Rhode Island Airport Corporation

ADDENDUM NO. 1
Invitation for Bids No. 36109
REHABILITATION OF DELIVERY DRIVE PARKING LOT
Rhode Island T. F. Green International Airport

Prospective proposers and all concerned are hereby notified of the following changes in the document(s) related to **IFB 36109**. These changes shall be incorporated in and shall become an integral part of the contract documents.

TITLE: **DEMOLITION PLAN**

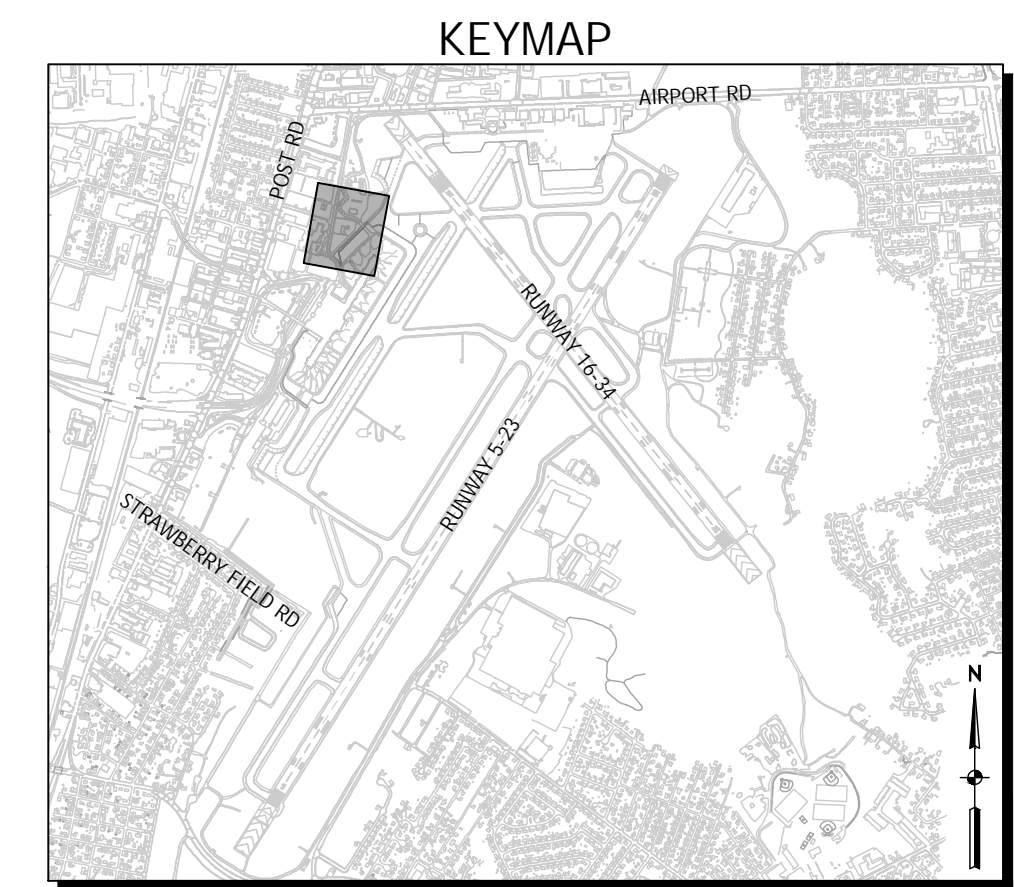
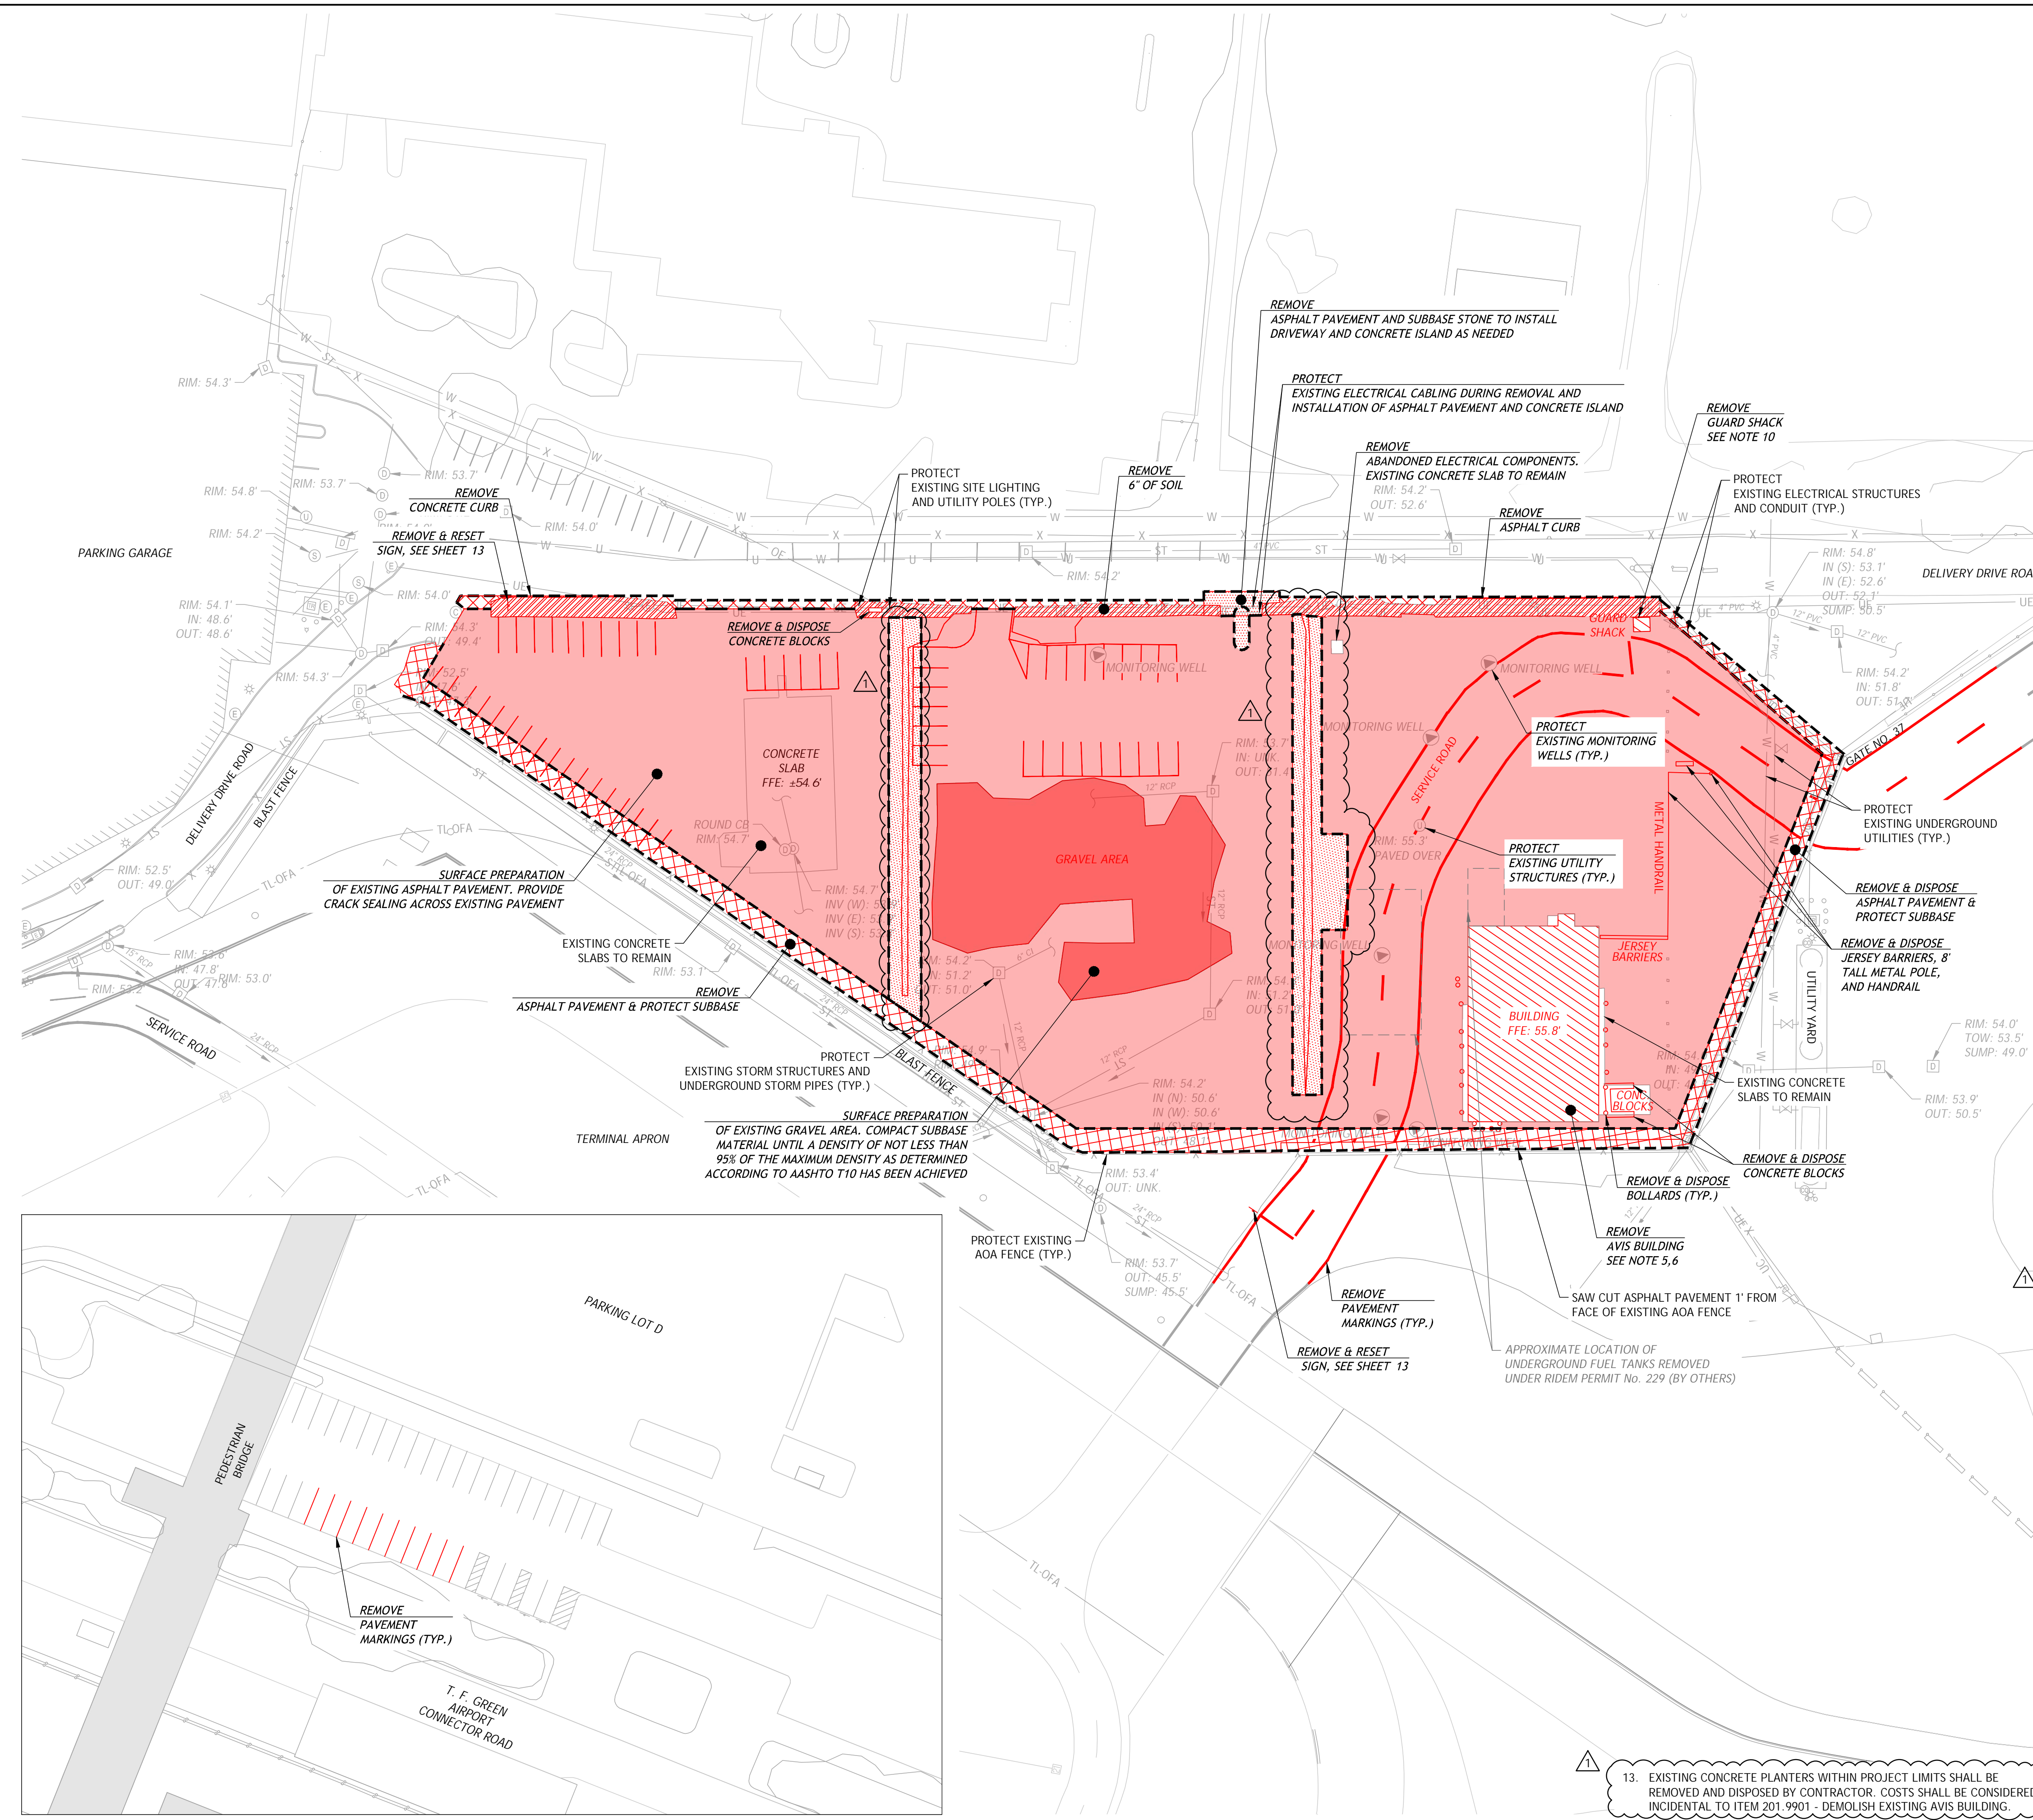
ii. Sheet 12

- Replace sheet 12 in its entirety and replace with sheet 12(R-1) attached to this addendum. Plans and Notes have been updated.

DRAWING NO. 13

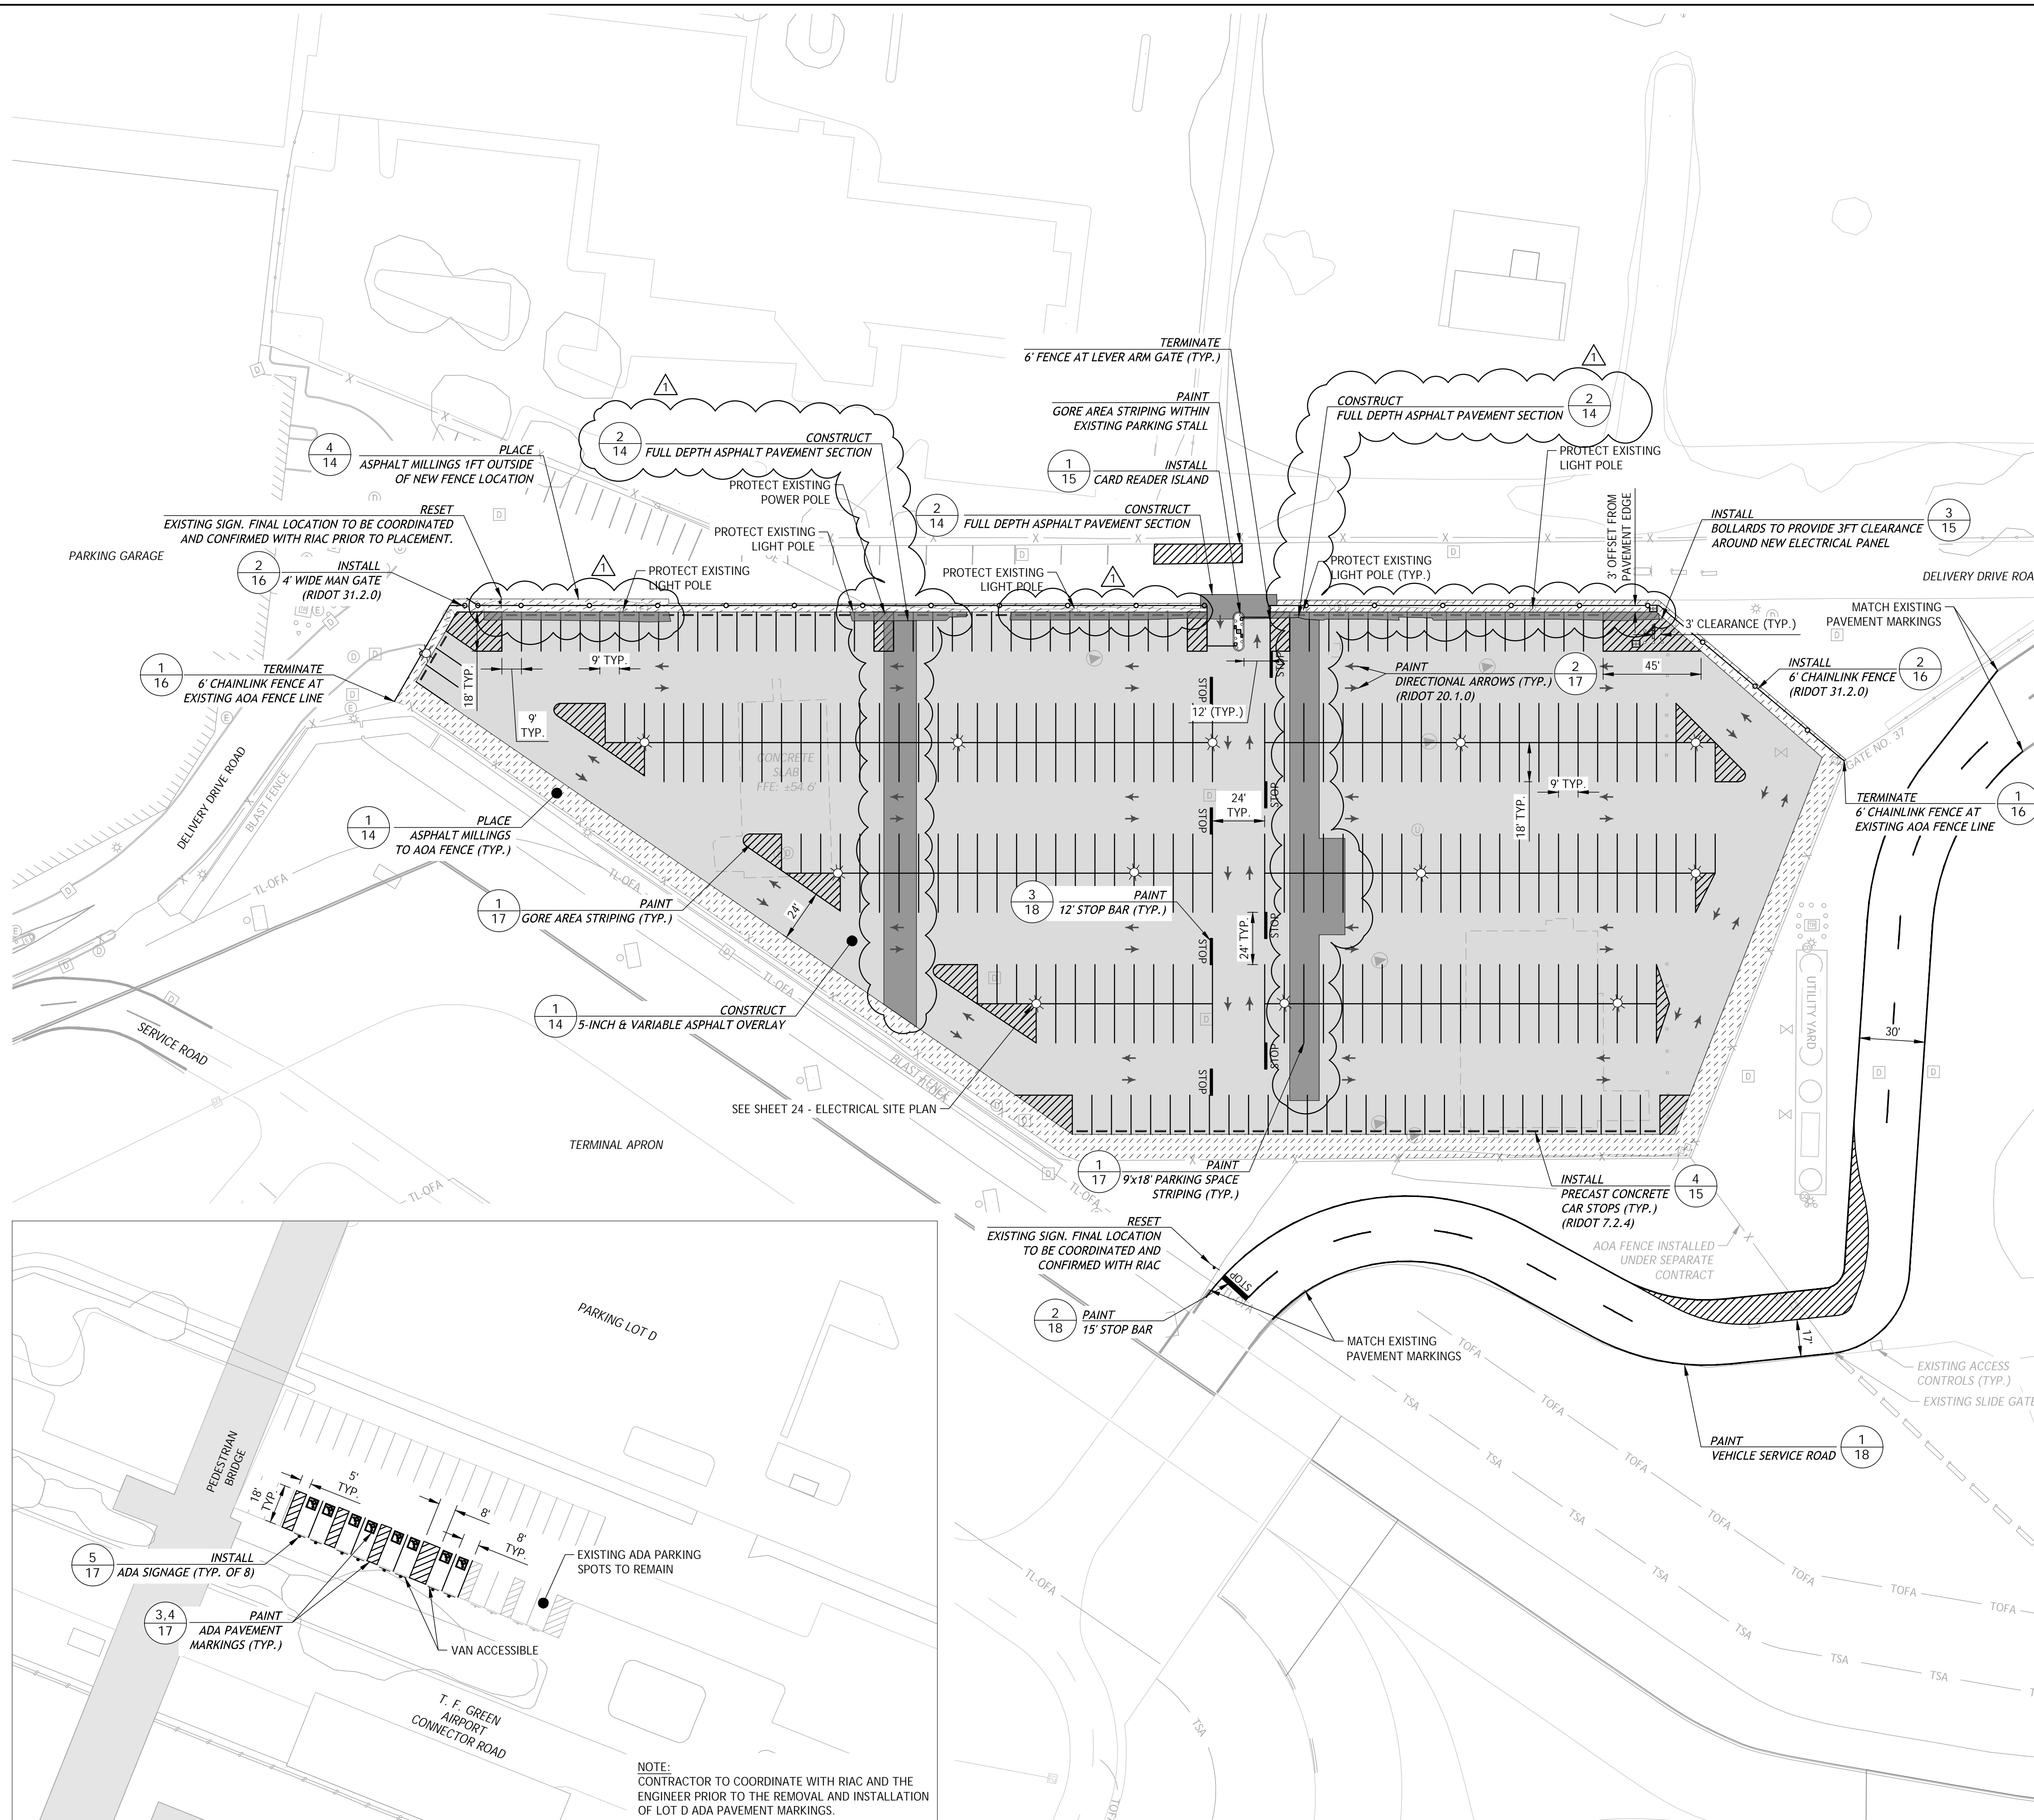
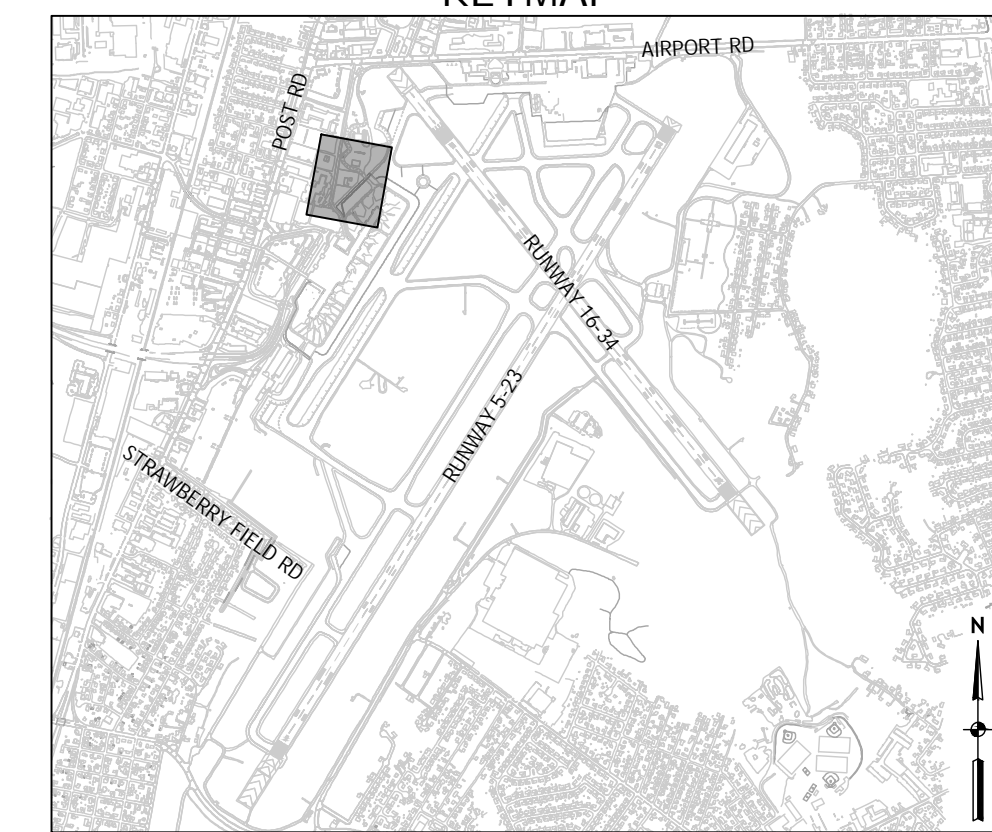
iii. Sheet 13

- Replace sheet 12 in its entirety and replace with sheet 13(R-1) attached to this addendum. Plans have been updated.
